THE RANCH SKETCH PLAN

LETTER OF INTENT

DECEMBER 2018, *REVISED MAY 2019*

Markup Summary 6-24-2019

Figure 7: Extract from the County Parks Master Plan

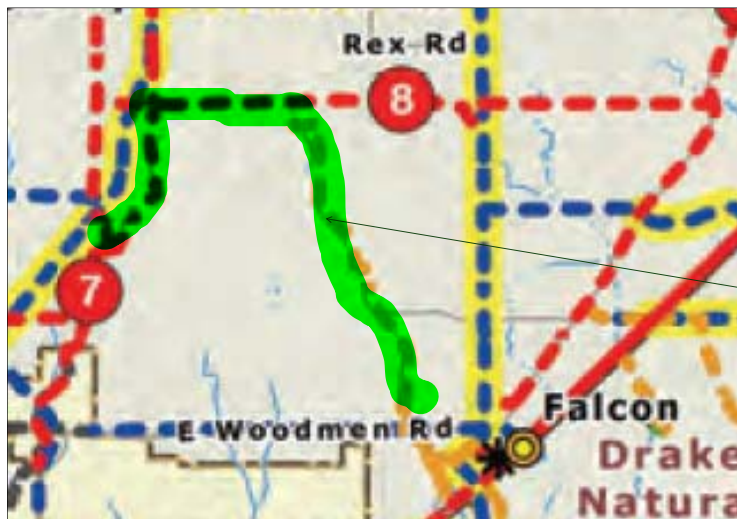
show the ranch prop
boundary; if the trail
runs south of
woodmen; show the
connections thru the
property or use
leaders and label

show the ranch prop boundary; if the trail runs south of woodmen; show the connections thru the property or use leaders and label

The Ranch Visual Analysis

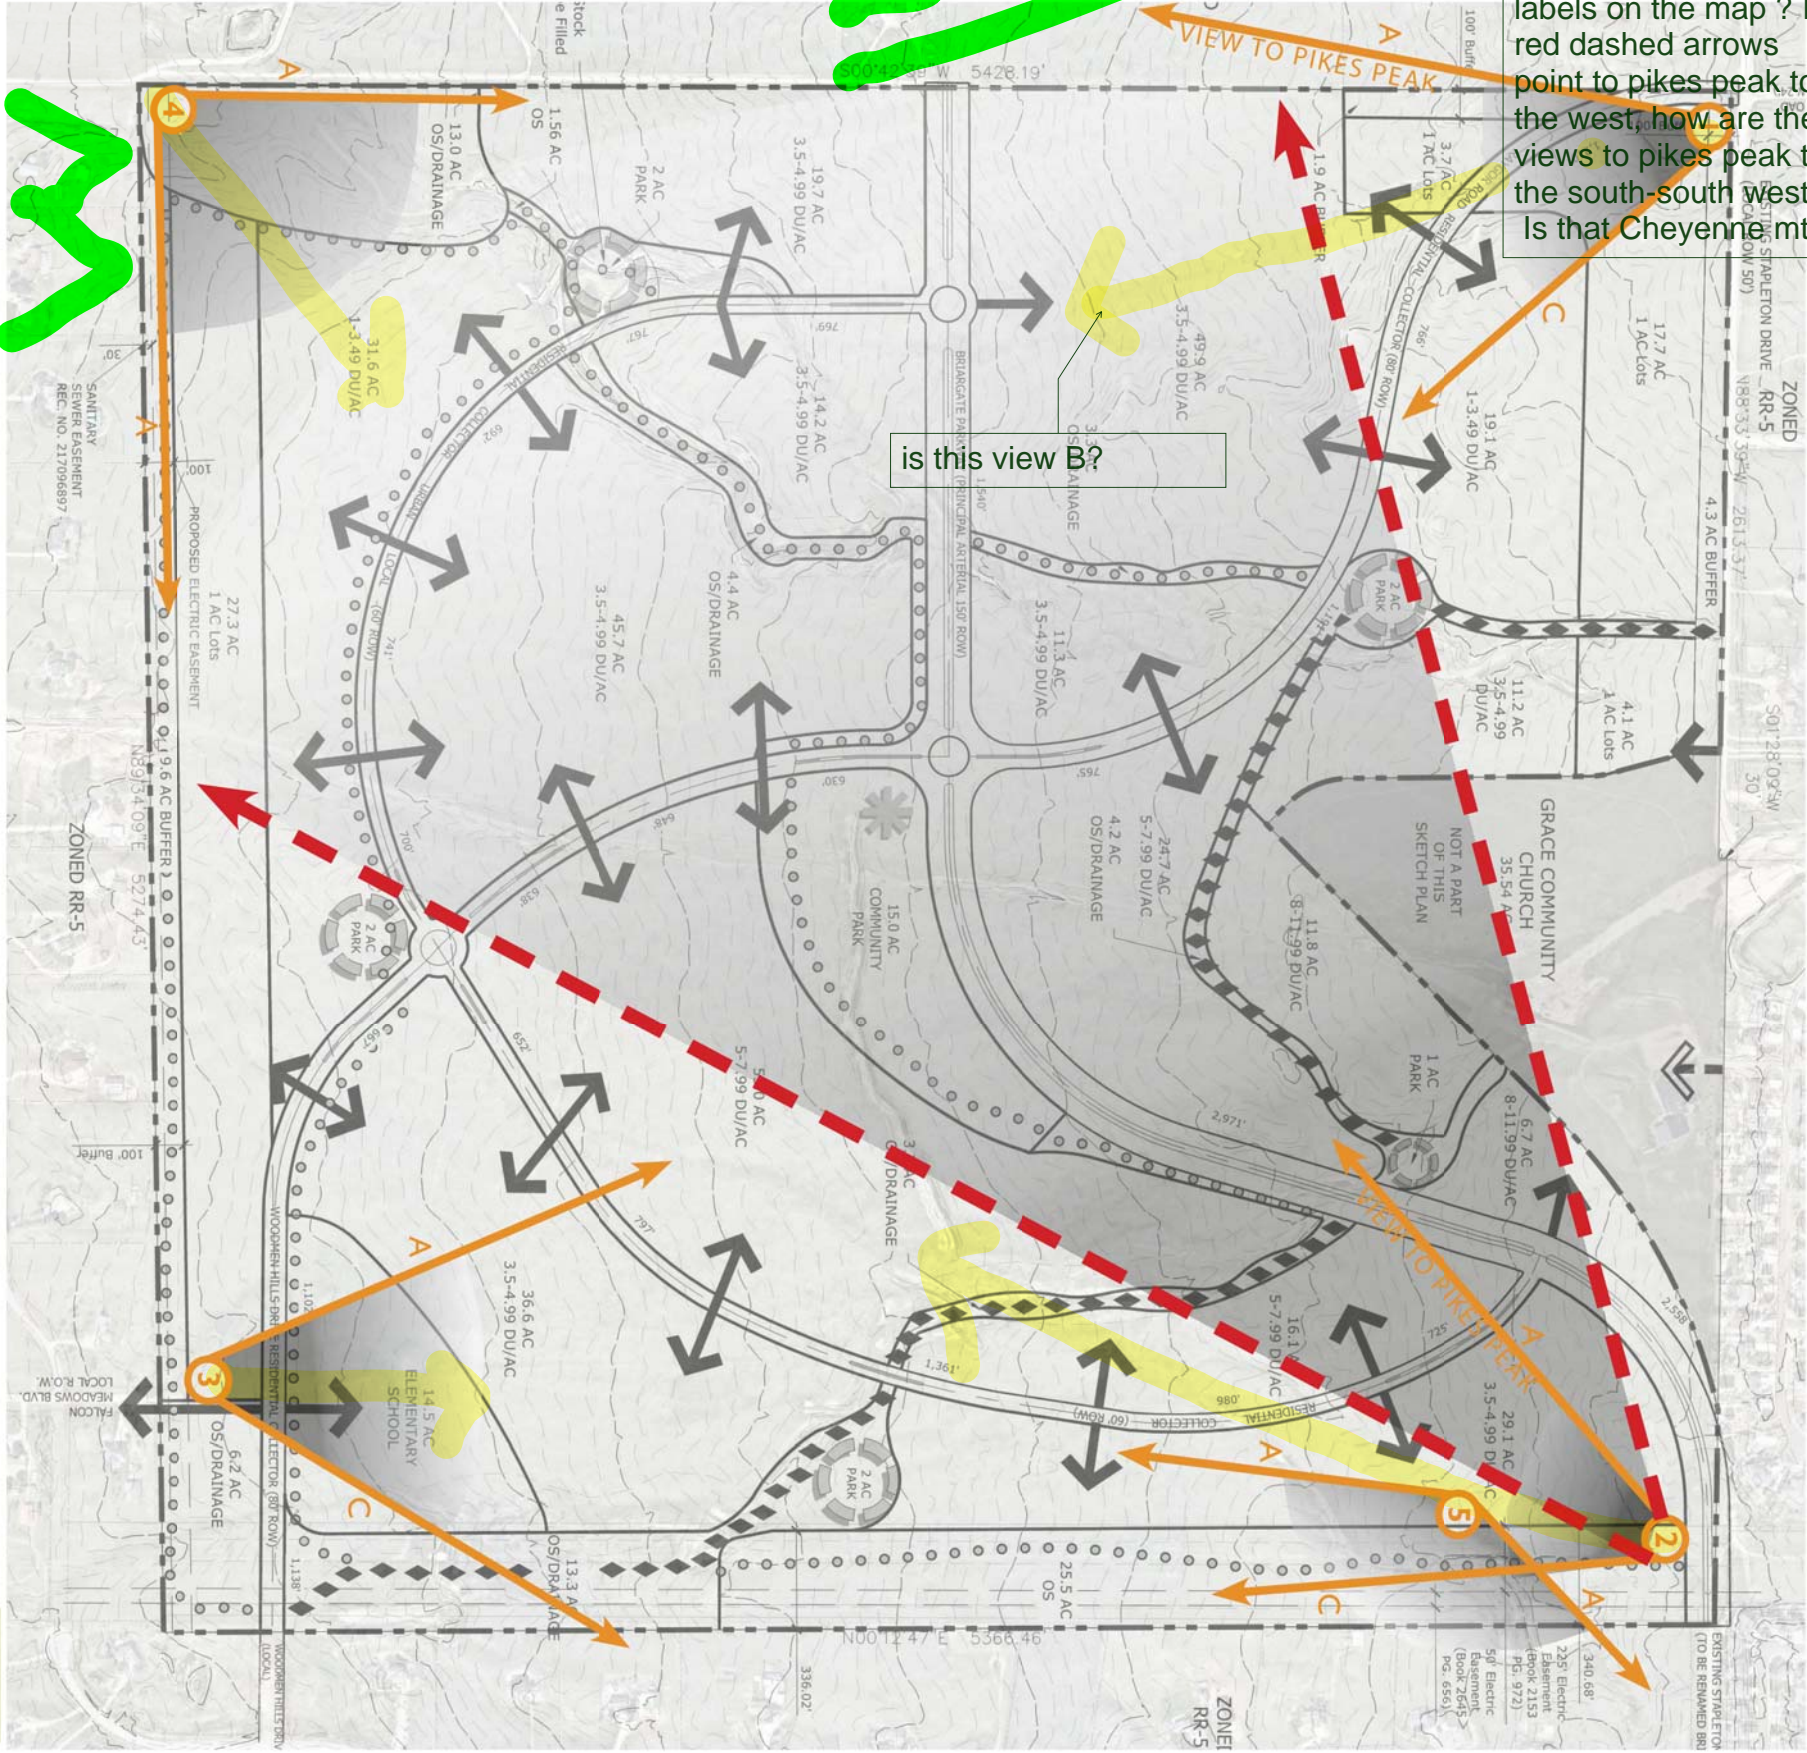
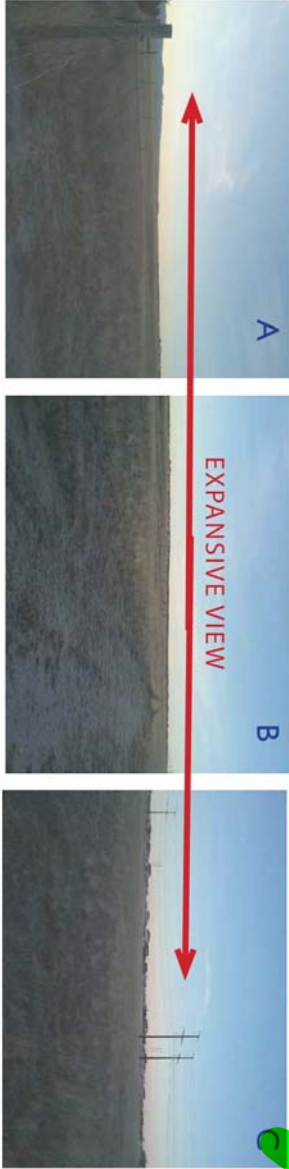
something is off here...where is B labels on the map ? If red dashed arrows point to pikes peak to the west, how are the views to pikes peak to the south-south west? Is that Cheyenne mt?

is this view B?

something is off here...where is B labels on the map ? If red dashed arrows point to pikes peak to the west, how are the views to pikes peak to the south-south west? Is that Cheyenne mt?

is this view B?
